TECHNICAL NOTE	
	Pringuer-James Consulting Engineers (Structural & Civil Engineers) Overseas House, Elm Grove, London SW19 4HE 	
Project: Tudor Cottage, Sea Road	Project No. L2340	
By: Vlad Myrsikov	Date: 17.12.2018	
Title: Drainage Design Cover Note	No. L2340-TN-002

Planning Application Reference: APP/C3810/W/17/3183667 and EP/136/18/PL

TUDOR COTTAGE, SEA ROAD,
EAST PRESTON

DRAINAGE FOR PLANNING

SECTION 1-1
Scale 1:25

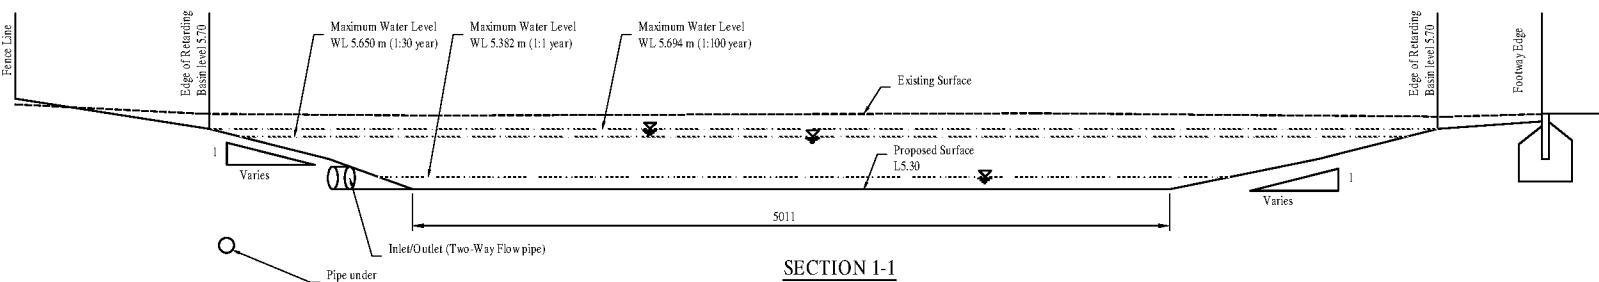
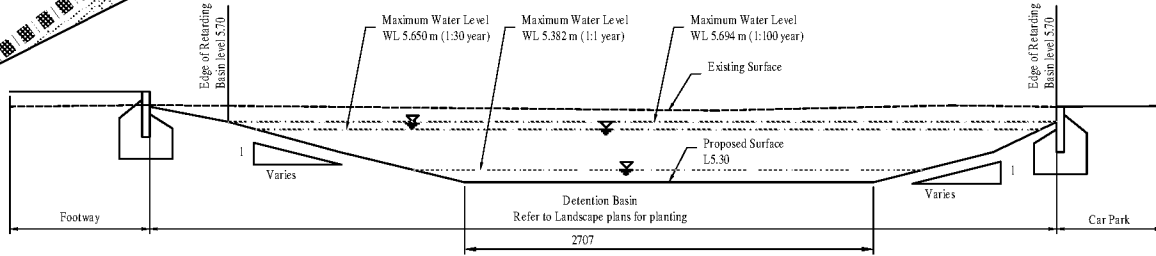
- The proposed development reduced run-off rate to 3x Greenfield Rate which is the standard expected for brownfield sites.
- Council has requested additional levels information for the Detention Basin.

- PJCE provided detailed set-out for the Detention Basin including levels and sections.
- The Council expressed desire to change “off-line” Detention Basin to “on-line” Detention basin, on an assumption that latter would decrease water run-off into the sewer through infiltration.

- The Council requested additional inlets and outlets to be provided into the basin.
 - PJCE increase the number of pipes entering and exiting the Detention Basin.

- PJCE has added water levels to Detention Basin cross-section to demonstrate water entering the basin even during average annual 1-in-1year storm. Off-line arrangement would be beneficial to landscaping and plant species.

FLOW CONTROL CHAMBER DETAIL
Scale 1:20

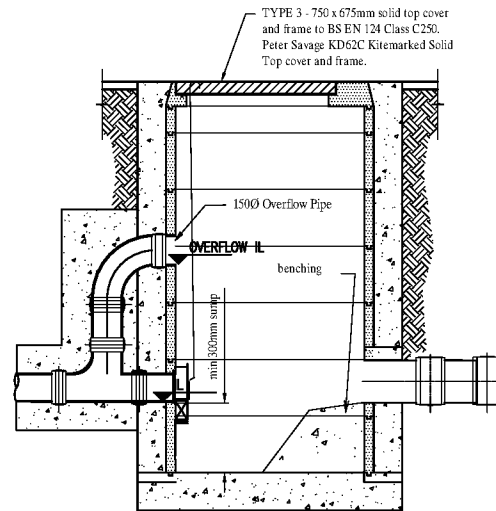
1. Please detail on the layout plan the pond invert levels and bank levels.
2. Please ensure all water goes through the pond before reaching the flow control device. I would advise two inlets to the pond and one outlet which has the flow control device. At the minute the water is being able to bypass the pond at flows which are less than the restricted rates, therefore whenever it was raining water would be going into the sewer. We would like to see the sewer connection used as more of an overflow.
3. Please provide calculations of this revised arrangement.
4. Please detail proposed levels of the car park area. As you have provided no quantifiable proof that your proposal for the car park would work can levels be set so that there is a gentle fall to the pond rather than surrounding land.
5. Please provide construction detail drawings of the non-engineered permeable pavement.
